ADDENDUM NO. 1 TO PROJECT NO. 47261

CONSTRUCTION WORK PROVIDE MASONRY REPAIRS, FAÇADE, BUILDING 40 CREEDMOOR PSYCHIATRIC CENTER 80-45 WINCHESTER BOULEVARD QUEENS VILLAGE, NY

January 9, 2026

MARK	DATE	DESCRIPTION
△	01/09/2026	ADDENDUM #1
	10/10/2025	FINAL SUBMISSION
PROJECT NUMBER: 47261 - C		
DESIGNED BY: NK / KH		
DRAWN BY: AB / KP / OG / VY		
FIELD CHECK:		
APPROVED: NK / PM		
SHEET TITLE: RESTORATION ASSEMBLY DETAIL - STN 03		
DRAWING NUMBER: A-539		
SHEET 108 OF 164

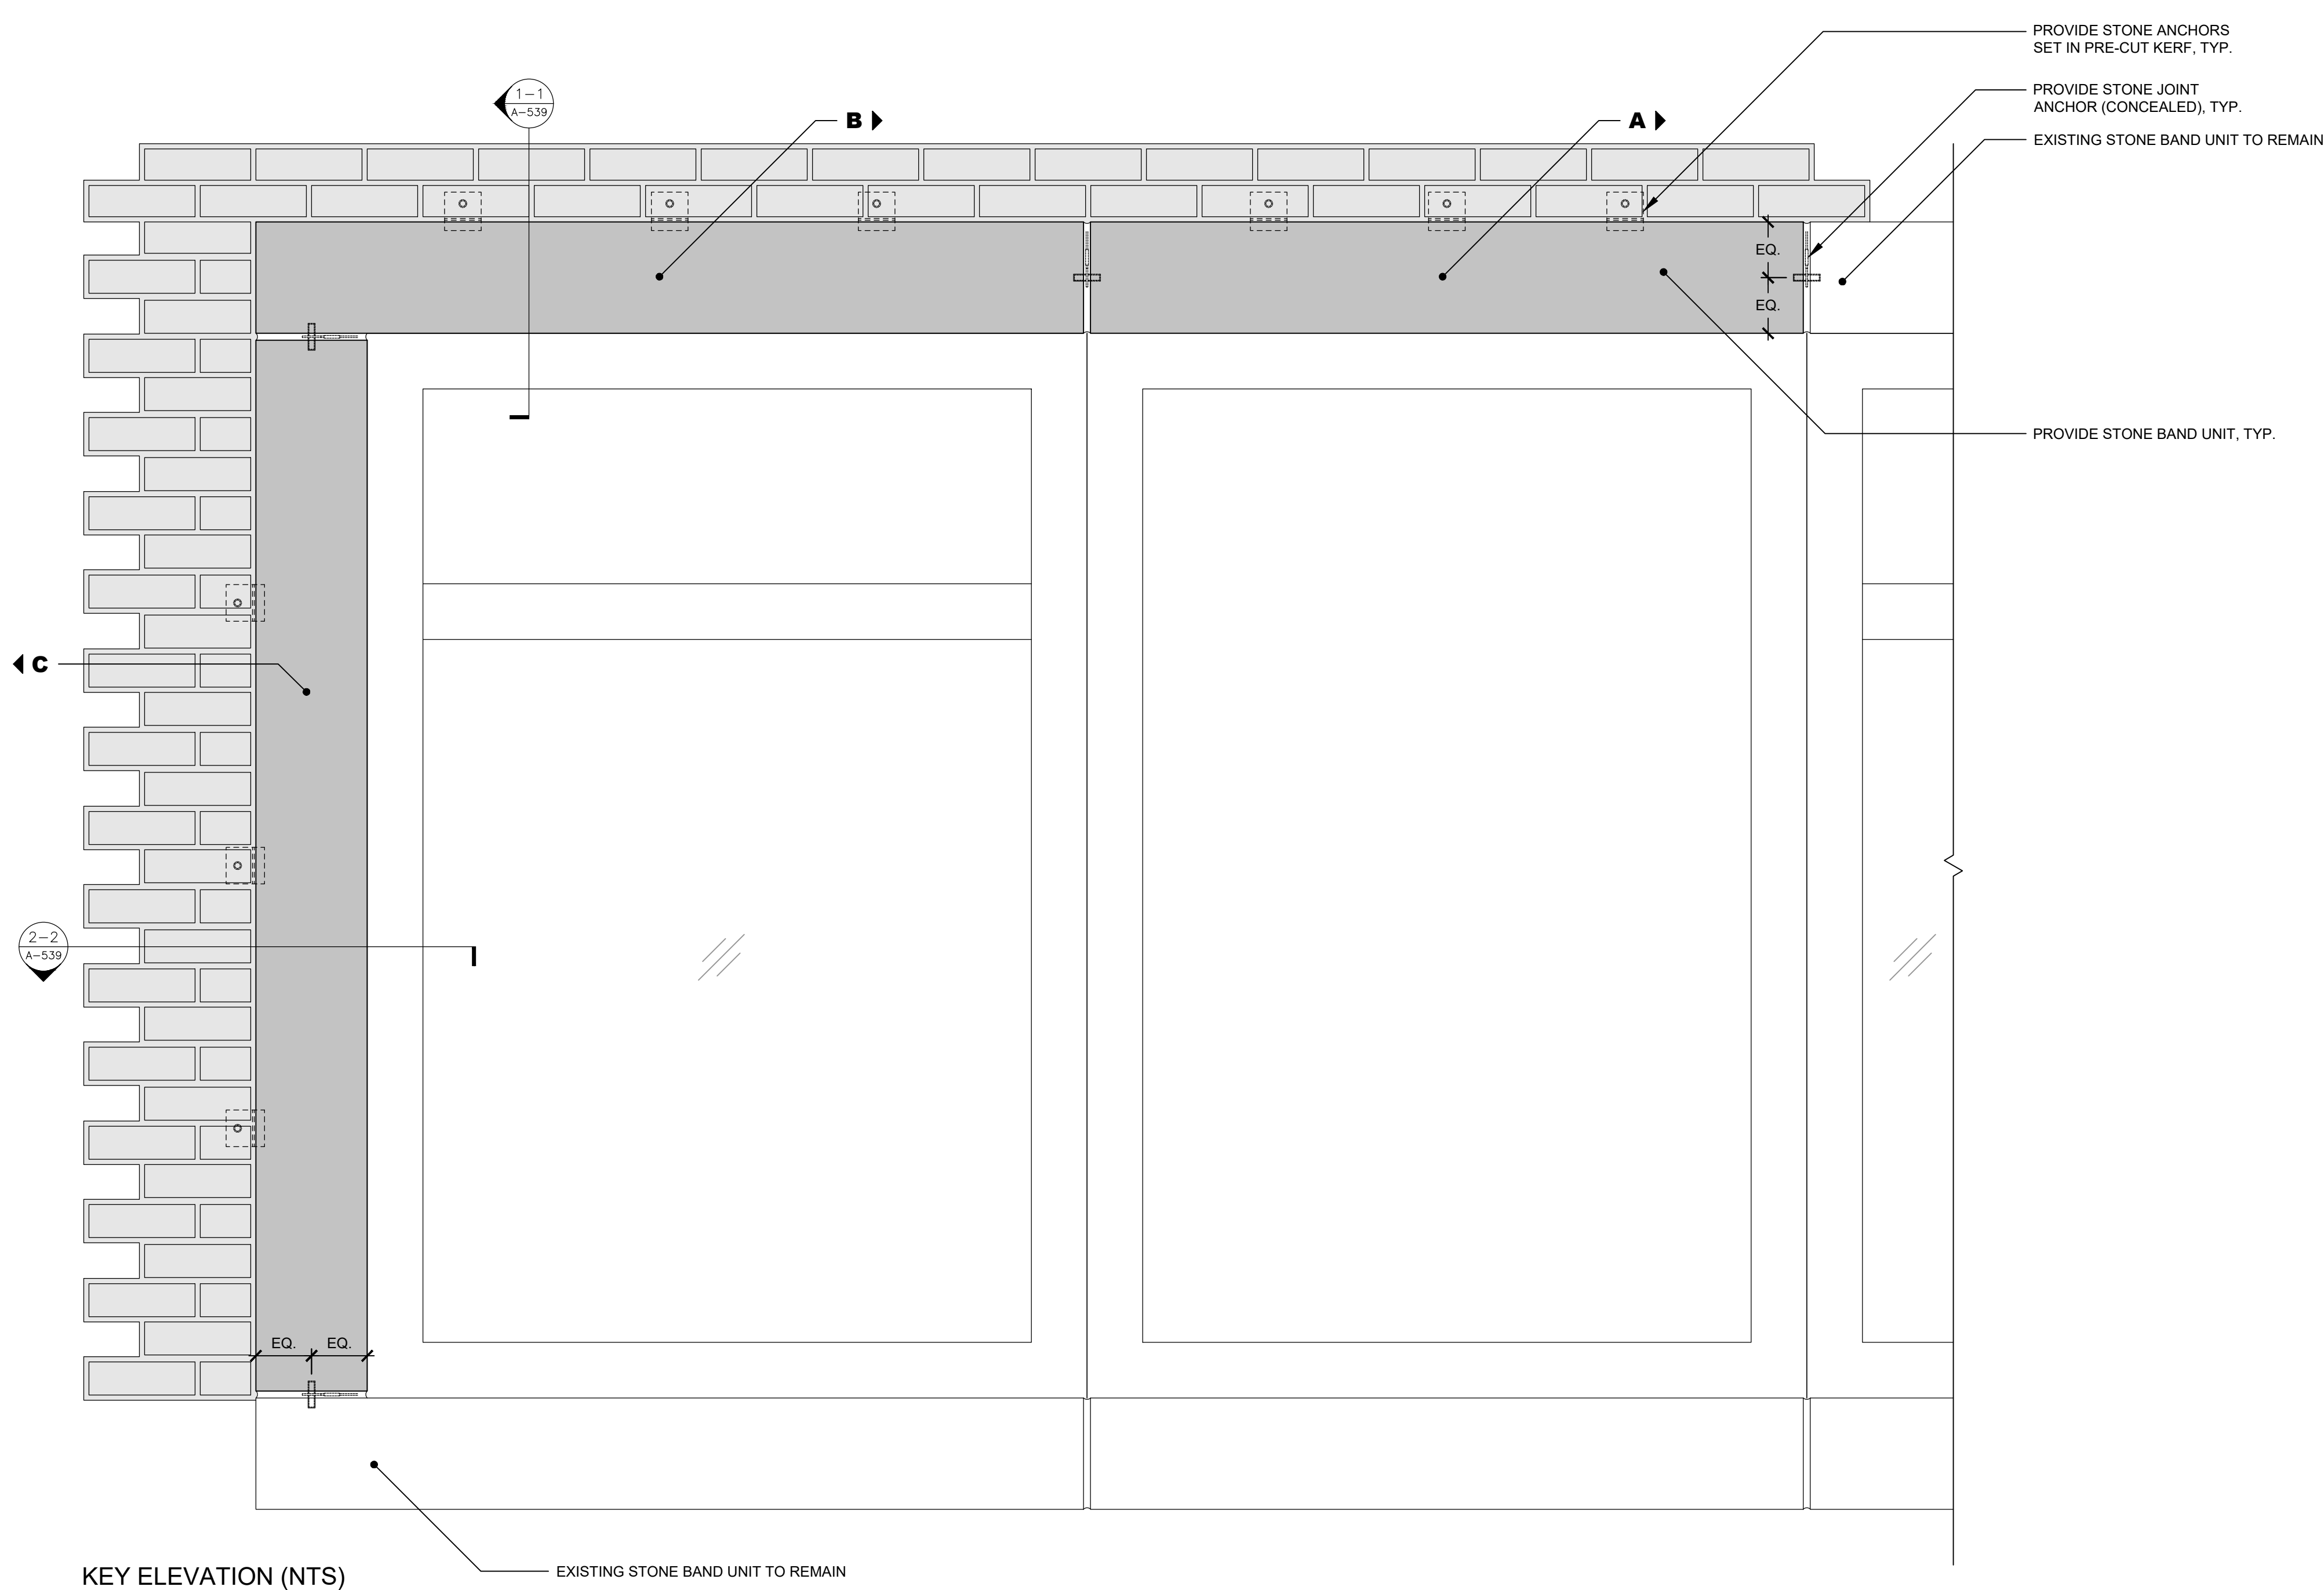
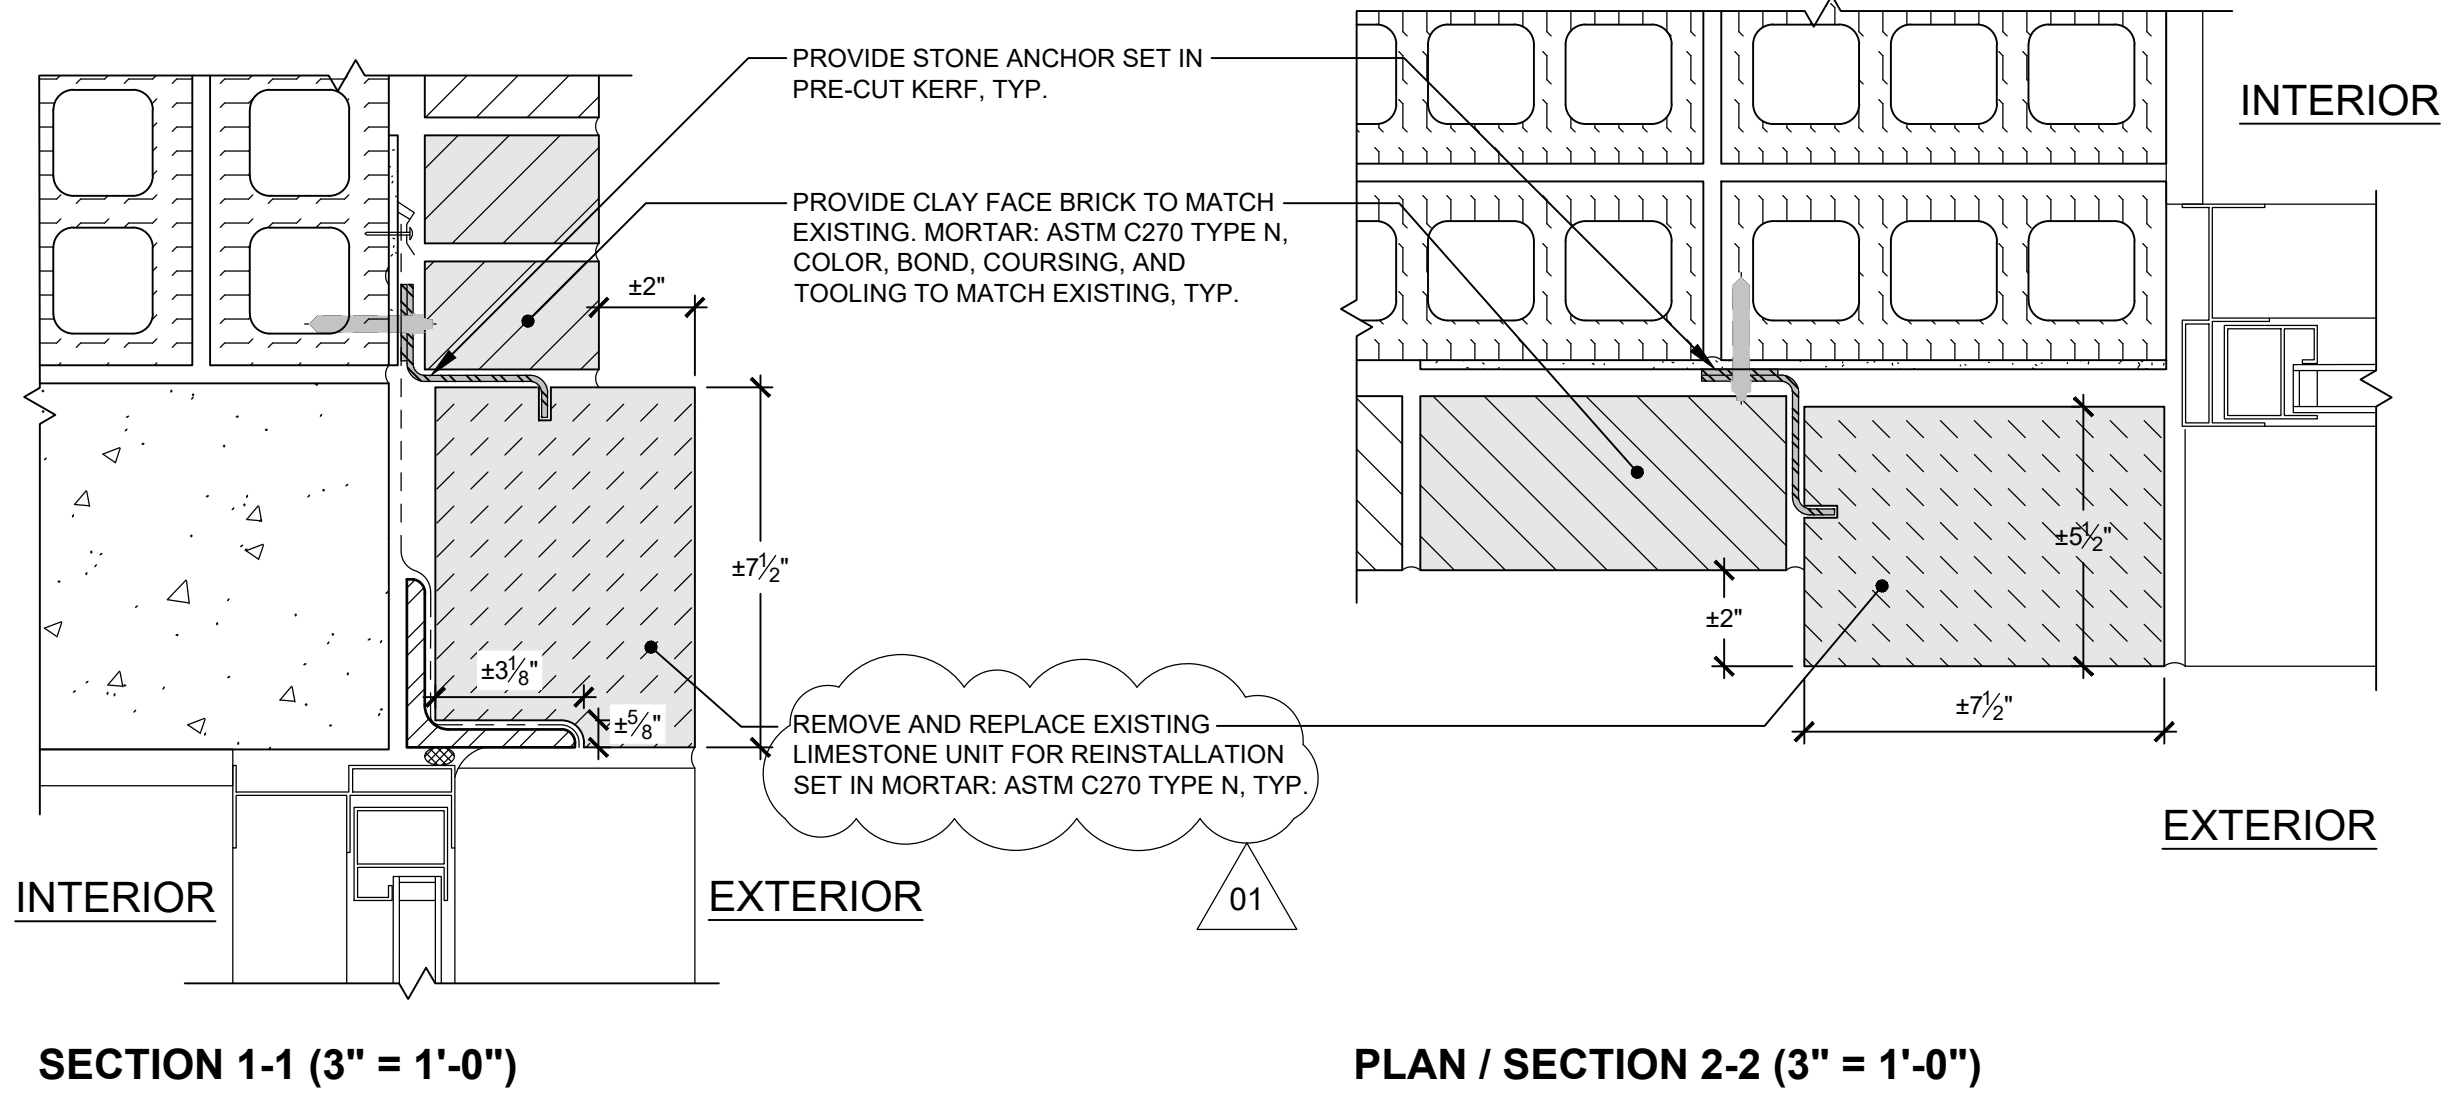
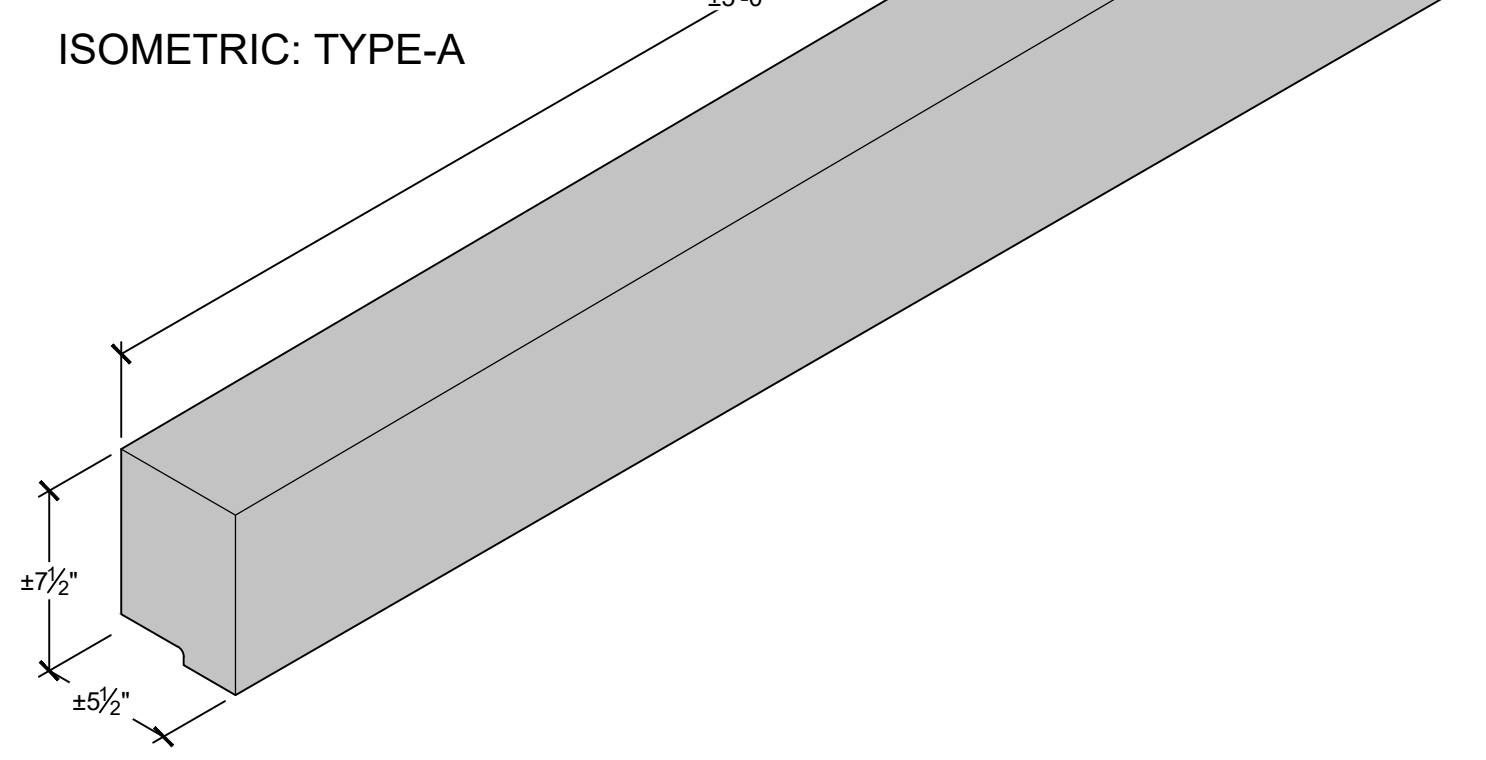
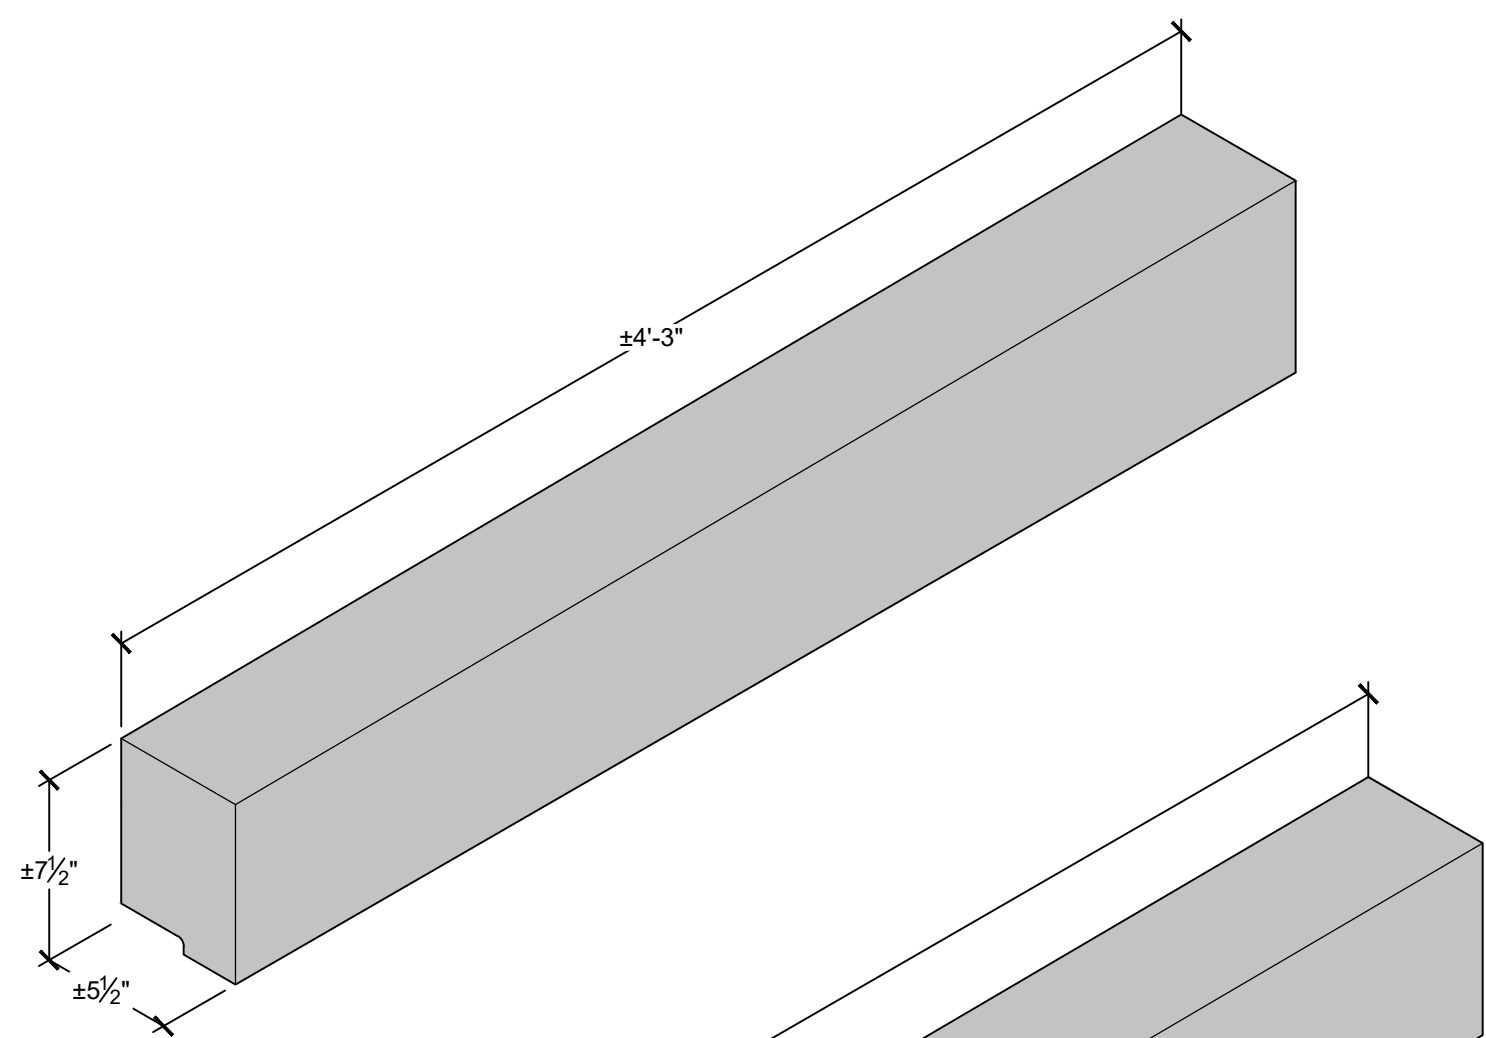
1. Drawing No. G-002
 - a. Delete “APPLICATION OF VAPOR BARRIER ON INTERIOR WALL AT MECHANICAL PENTHOUSE” bullet point from list of Summary of Work in its entirety.
2. Drawing No. G-005
 - a. Detail FLA 03 is omitted.
3. Drawing No. A-402
 - a. Updated Roof M Plan to include details DEM 03 & DEM 04. Included graphics for the NY State cable and lightning protection cable. Removed tag for FLA 03 (omitted). Updated graphics for removal for steel tubes.
4. Drawing No. A-501
 - a. Included details DEM 03 & DEM 04.
5. Drawing No. A-504
 - a. Detail FLA 03 is omitted.
6. Drawing No. A-509
 - a. Included photo of existing cables to be temporarily removed and reinstalled along guardrail.
7. Drawing No. A-539
 - a. Included note of location of traffic coating application.
